May 17th, 2017

**Subject: LEPCN41249 - Voltage Upgrade for 345 Series Panel Mount and PCB Mount Holders**

**345 Series Panel Mount - Prior version**

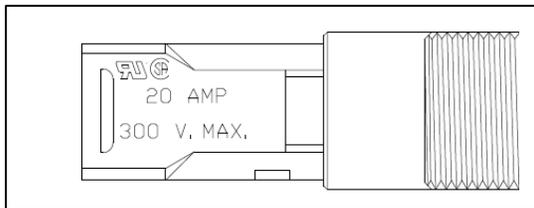
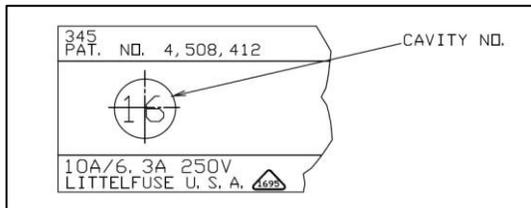
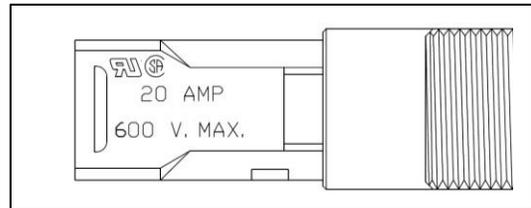
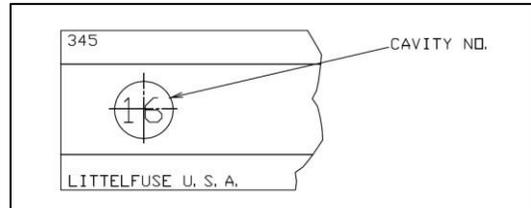
For the **0345 Panel Mount Series**: There is no change in design, form, or fit. The voltage rating is improved from 300 V up to 600 V for the 345 600, 345 700 and 345 900 Series; certified by UL/ CSA. The voltage mark will be changed from “300 V” to “600 V” on the holder’s plastic body. (Please see below for reference)

**345 121 and 345 101 Series  
Prior version**

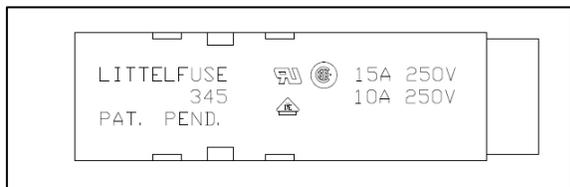
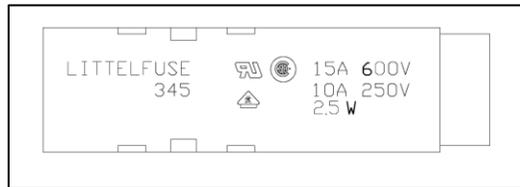
For the **0345 PCB Mount Series**: There is no change in design, form or fit. The voltage rating is improved to 600V certified by UL/CSA. The voltage mark will be changed from “250 V” to “600 V” on the holder’s plastic body. VDE voltage will remain the same at “250 V”. (Please see below for reference)
